Access Compliance Report

Public Rights-of-Way

Intersection ID: 48133	Main Street: WHISTLER'S CHASE DR	Cross Street: ACORN CREEK LN	Location: SE
ADA ID: C96AE5CA821B	Ramp Type: PerpDiag	Initial Pass/Fail: Pass	Overall Compliance: No
Severity Score: 7.75			
Codes/Mitigation Info/Possible Solution		Field Measurements/Component Compliance

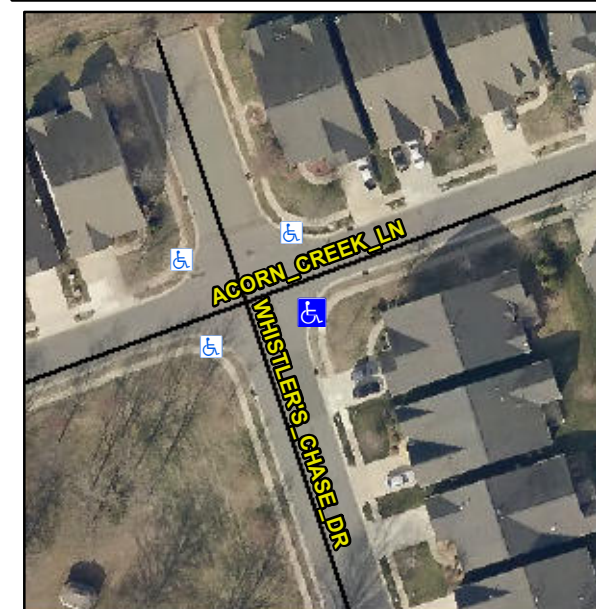
Not Found, R304.5.3, R304.2.2-Perp, R304.3.2-Para, R302.7.2

Compliance	Description	Data	Compliance	Description	Data
N/A	Ramp Length (in)	45.5	Yes	Ramp Slope (%)	5.9
Yes	Ramp Width (in)	48.0	No	Ramp XSlope (%)	3.5
N/A	Flare Type LT	Sloped	N/A	Flare Type RT	N/A
N/A	Flare Slope LT (%)	7.8	Yes	Flare Slope RT (%)	2.1
N/A	Flare Traversable LT?	Yes	N/A	Flare Traversable RT?	Yes
Yes	Landing Length (in)	48.0	Yes	DWS Provided?	Yes
Yes	Landing Width (in)	48.0	Yes	DWS Contrast?	Yes
No	Landing Slope (%)	2.6	Yes	DWS Length (in)	24.0
No	Landing X Slope (%)	3.0	Yes	DWS Full Width?	Yes
N/A	Landing Curb? (Y/N)	No	Yes	DWS Offset (in)	2.0
N/A	Shared Landing?	No			
Yes	Gutter Ponding?	No	Yes	Gutter Slope (%)	0.5
No	Gutter Lip Ht (in)	0.5	Yes	Gutter X Slope (%)	1.2
N/A	Painted X Walk1?	No	N/A	Painted X Walk2?	No
	X Walk 1 Direction	To N		X Walk 2 Direction	To W
N/A	X Walk 1 Width (in)	N/A	N/A	X Walk 2 Width (in)	N/A
	X Walk 1 Slope (%)	4.5		X Walk 2 Slope (%)	4.0
	X Walk 1 X Slope (%)	1.1		X Walk 2 X Slope (%)	4.5

Remove & Replace Curb Ramp With Two New Directional Ramps or Equivalent.
